**LEXINGTON-FAYETTE URBAN COUNTY GOVERNMENT
 CONTRACT CHANGE ORDER**

Date:	November 27, 2017
Project:	Morton House Improvements
Location:	530 North Limestone
Contract No.	567-2017
Original Contract Amt.	\$43,000.00
Cumulative Amount of Previous Change Orders	\$0.00
Percent Change - Previous Change Orders	0.00%
Total Contract Amount Prior to this Change Order	\$43,000.00
Change Order No.	1

Re: Request for Change Order to Morton House Improvements
Bid #103-2017, Resolution #567-2017

**GATEPOST REHABILITATION
530 NORTH LIMESTONE**

DRIP
DETAIL

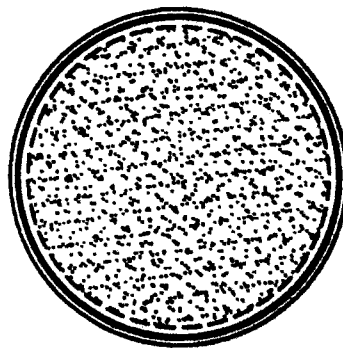
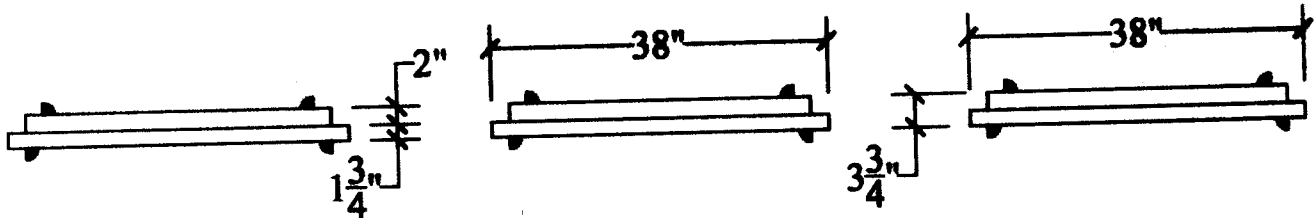
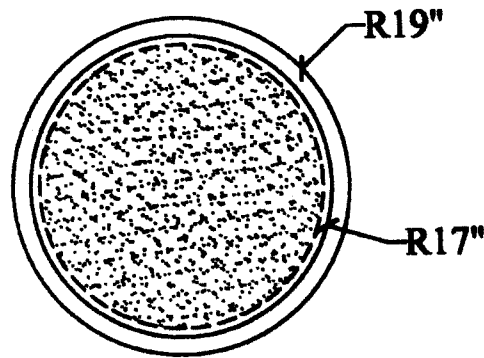
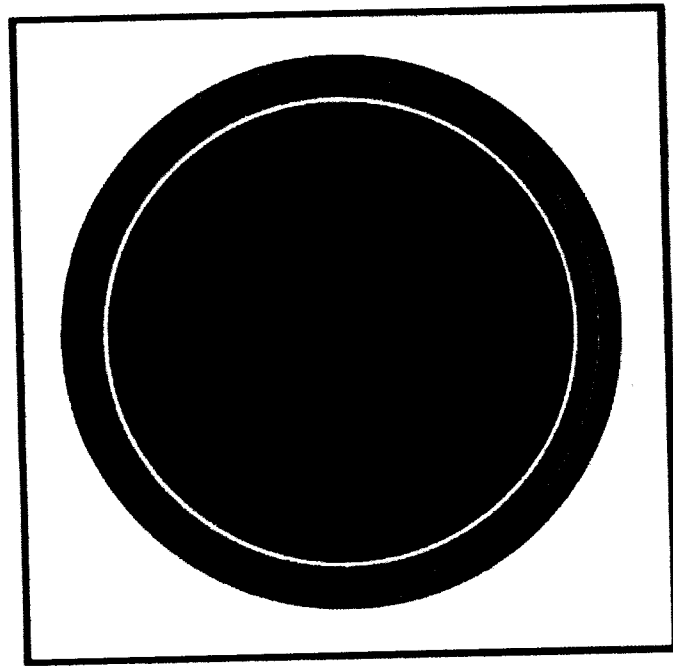
Add to the cost of the contract for providing one additional stone beneath the caps the city has in storage. The plans asked that we provide one new stone but it was later discovered that two new stones are needed. The cost of this new stone is \$690.00. Installation was included in the original bid.

COLUMN TOP VIEW

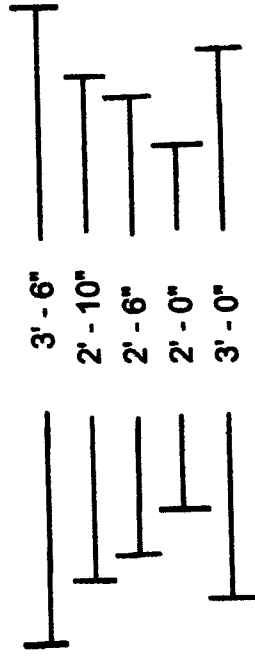
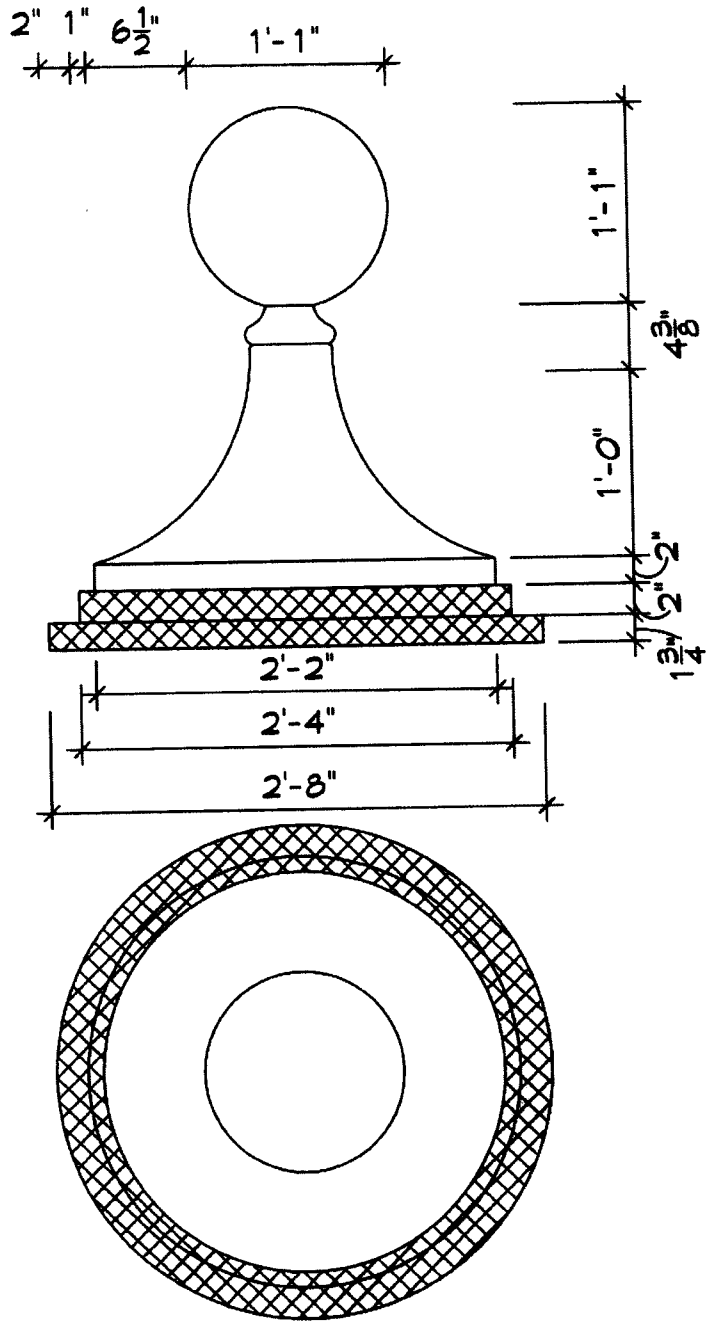
1. Necessity for change: Credit for the city to provide and install all conduit and connections as needed for electrical service to the storage container in the *credit* amount of \$1,453.00. After review with Bettie Kerr, a credit was given for using a sonotube for the structure of the gate posts in lieu of relaying the posts entirely out of brick for a *credit* of \$2,920.00. New stone caps to replace broken/damaged stone caps for the gate posts for \$690.00. Replace damaged block and tuckpoint and caulk in the play area at the daycare portion of The Nest for \$4,745.00. No additional days to the construction schedule.

Deduct the cost of laying the brick on the columns, \$2,350.00 for labor and \$570.00 for materials. Total deduction \$2,920.00

- OUTSIDE DIMENSION OF STONE FOUNDATION
- OUTSIDE DIMENSION OF PLASTER
- 30" DIAMETER SONOTUBE
- REBAR CAGE (VERTICAL BARS #5 HORIZONTAL BARS #4)
- OUTSIDE DIMENSION OF BASE RING OF PLASTER
